OFFICE OF THE PRINCIPLE CHIEF CONSERVATOR OF FOREST, HOFF, RAJASTHAN, JAIPUR

CCF resubmitted the proposal after amendment corrections. User Agency submits digital maps of the proposal FP/RJ/Road/6954/2014 as per required by MOEF & CC for their letter no.8B/Raj/06/4/2015/FC/1368 dated 11.03.2016. After examination of digital maps some query in the submitted digital maps.

Sheet no 1

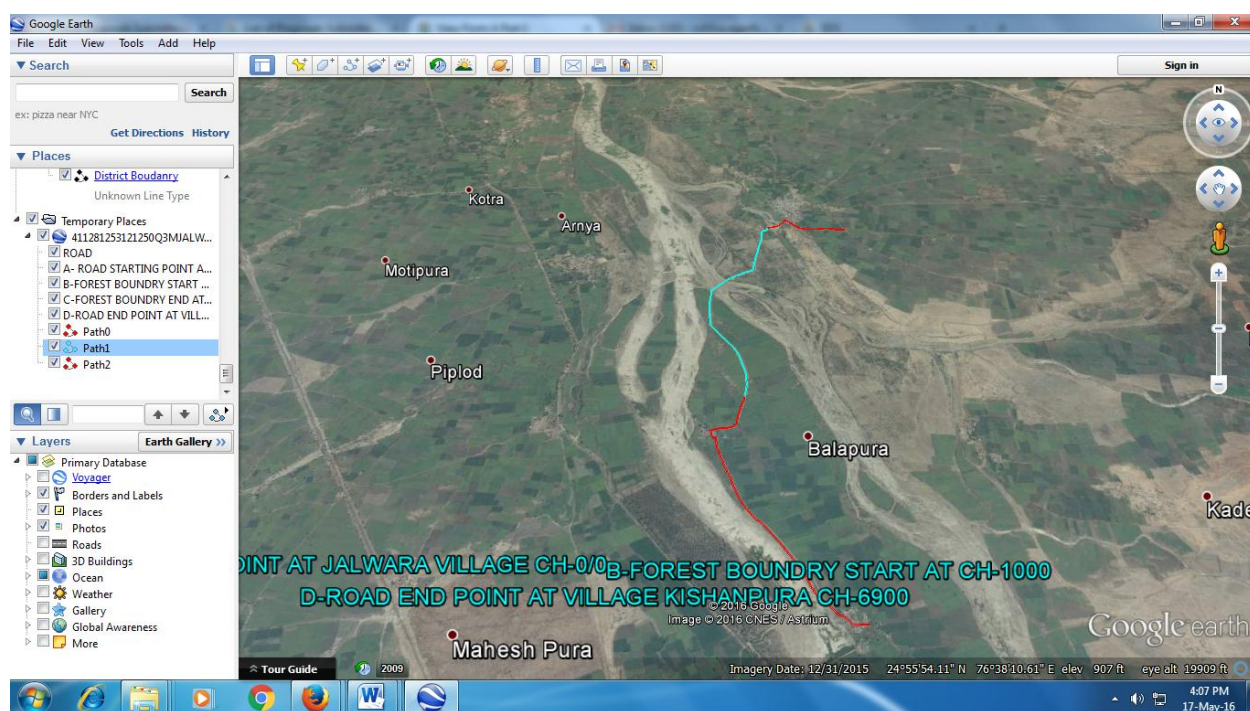
1. Digital Maps are in polyline shape while MOEF & CC required digital maps in polygon shape for DSS analysis.
2. Sheet No 1 expressed that provided digital maps are prepared in path. Total path are 3.
3. Sheet no 2 expressed that provided digital maps are in line shape.
4. Sheet No 3 expressed that provided digital maps have a length of 5932 meter in forest while the length of road in forest is only 2960 meter.

Hence, Digital maps are not satisfactory, the proposal is to be forwarded to CCF for modify/ revised digital maps.
